TECHNICAL INSTRUCTION NO. 39.

Slingsby T.53.B. - Mod. No. 14

MODIFICATION TO FUSELAGE BETWEEN FRAMES 4 AND 6.

It is required to modify the centre section of the T.53.B. fuselage by the extension of the lower stringer and by stiffening and strengthening the skin in the area between frames 4 and 6.

FIG.1

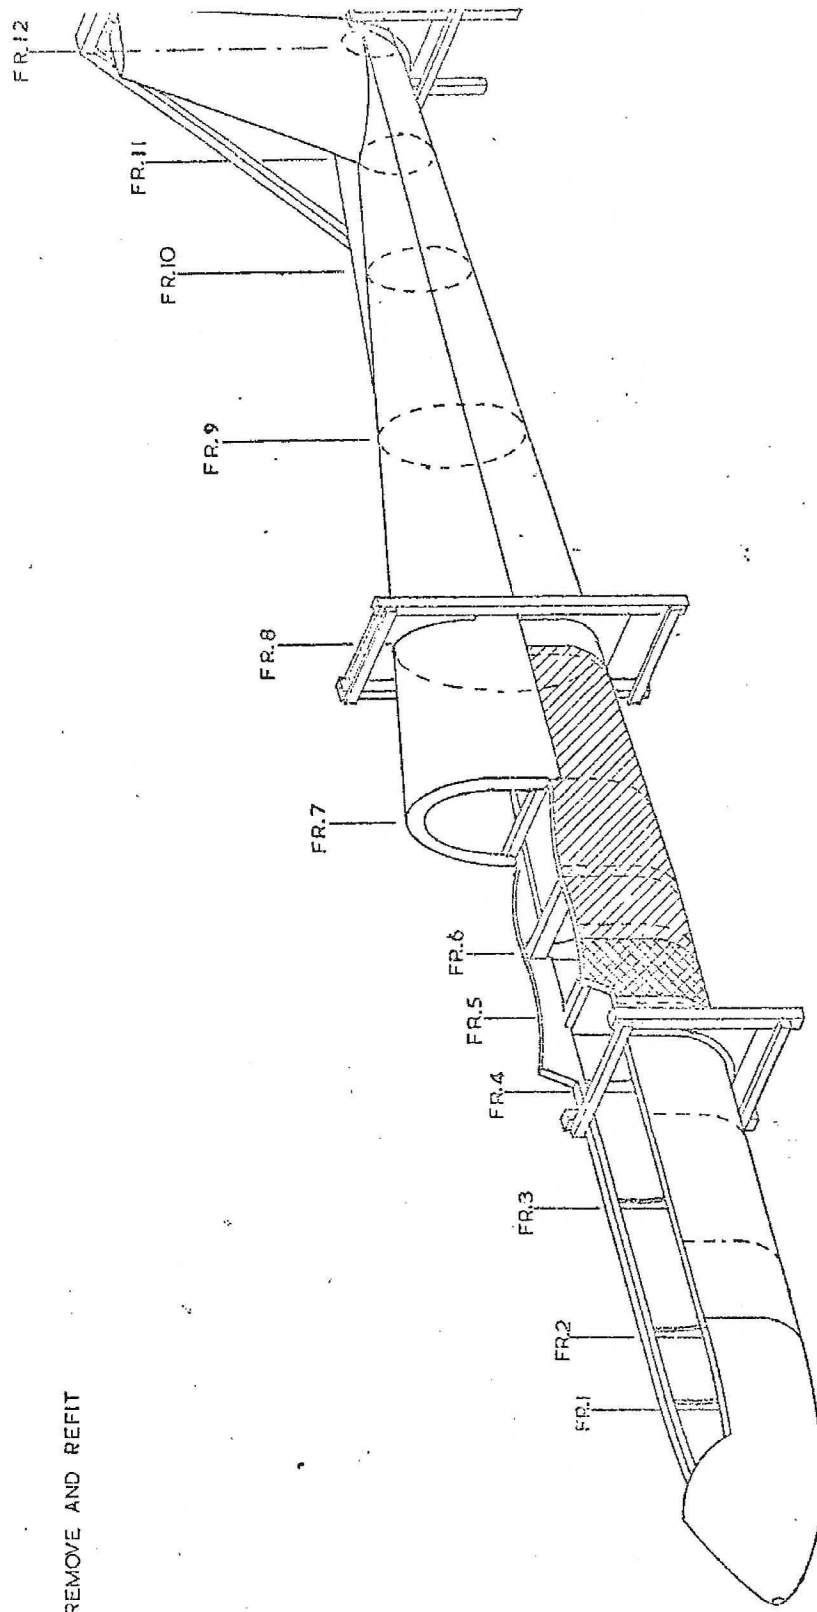
1. The fuselage is to be held rigid at three points, the fin at the tailplane pick up and in a contour board at frame 12, between two contour boards at frame 8 and on the steel crutch frame 3" fwd. of frame 4. See Fig. 1.

2. With the aircraft fully supported the skin panels shaded in Fig. 1. are to be drilled off. A sharp drill must be used at all times and great care must be taken not to damage the holes in the remaining structure.

REMOVE AND REPLACE WITH NEW 20G. (036) SKIN

REMOVE AND REFIT

FIG. 2

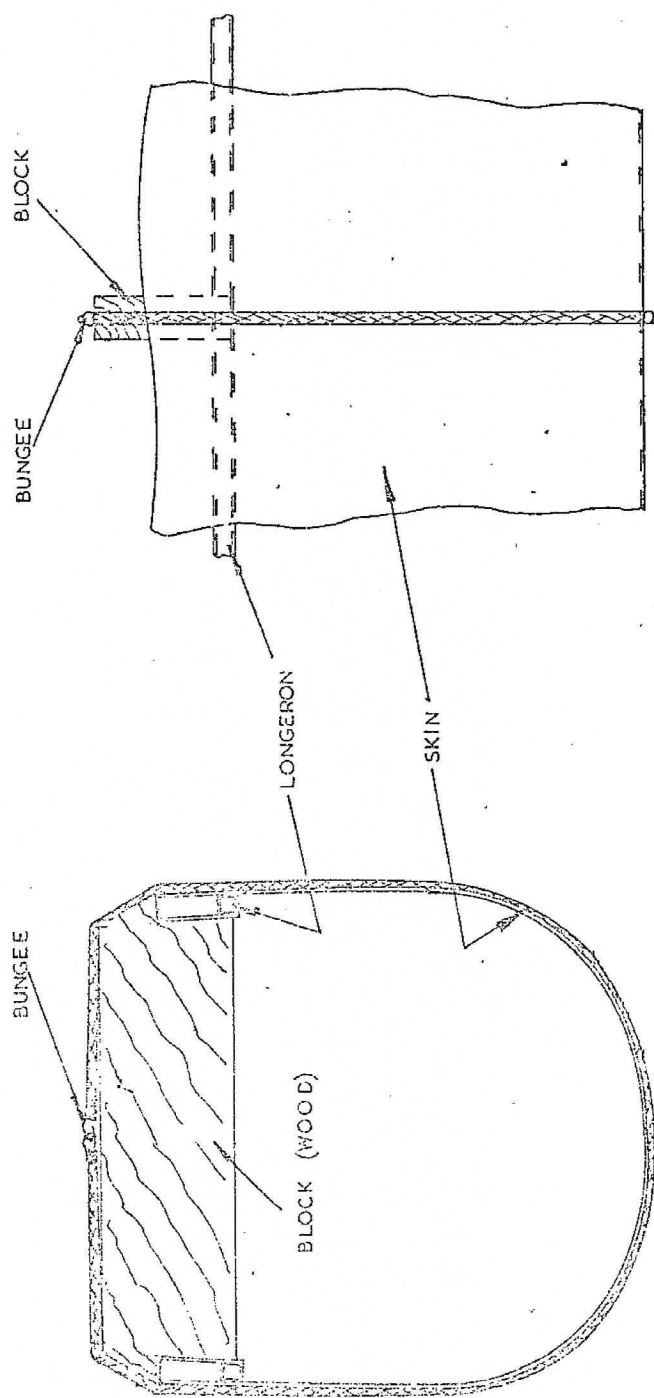
7. The skin is then offered to the aircraft and held by riveting clamps in the eight holes.
8. Strong bungees are fixed around the skins to hold the skins firmly to the frames. See Fig. 2.

TYPICAL BETWEEN
FRAMES 5 & 6 & 6 & 7
